Ohio Environmental Protection Agency (OEPA)

Ravenna Army Ammunition Plant (RVAAP)

2010 Correspondences

FIGURE 1. LOG-PROBABILITY PLOT OF ARSENIC DATA WITH ROS VALUES FOR NONDETECTS.

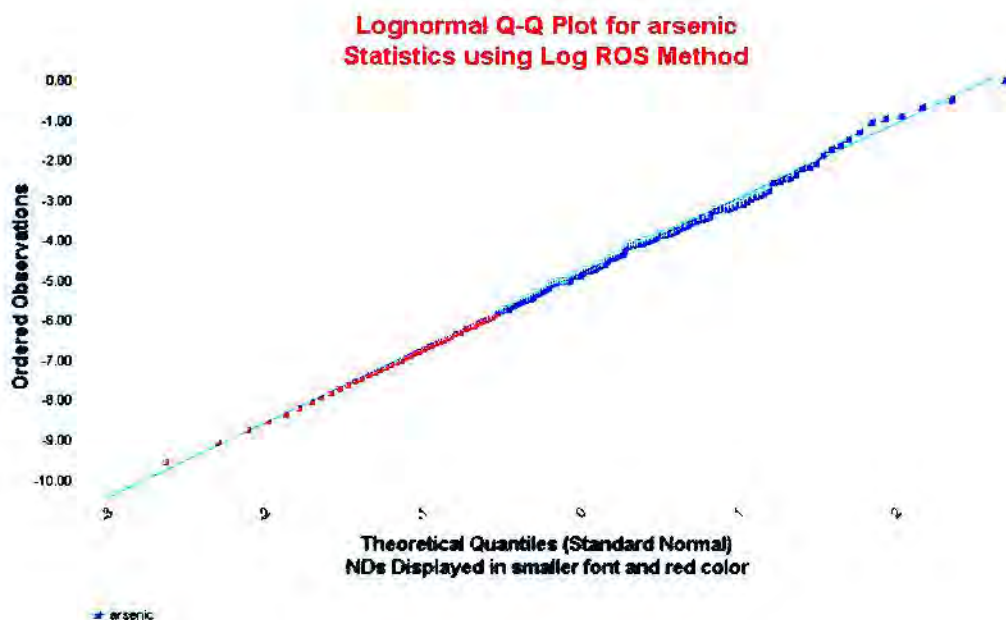
To test the applicability of the ROS method to these data, Ohio EPA re-evaluated the data for four elements – arsenic, chromium, nickel, and vanadium – that all had about

30 percent nondetects. In all four cases, these data sets were originally judged to follow nonparametric statistical distribution, using the method detection limit as the nondetect value (see Table 7-3). However, when the ROS method is used to generate the nondetect values, all four follow excellent lognormal distributions. The figure below shows a plot of the arsenic data on log-probability axes (the vertical axis is the natural log of the value and the horizontal axis is the number of standard deviations from the mean). Data from a lognormal distribution should plot as a straight line on these axes. The values above the detection limit are shown as blue points while the ROS generated values for points below the detection limit are given in red (Ohio EPA used ProUCL to develop this plot).

The plot shows that values above the detection limit clearly follow a lognormal distribution. Thus, it is reasonable to assume that values below the detection limit also follow the same distribution.
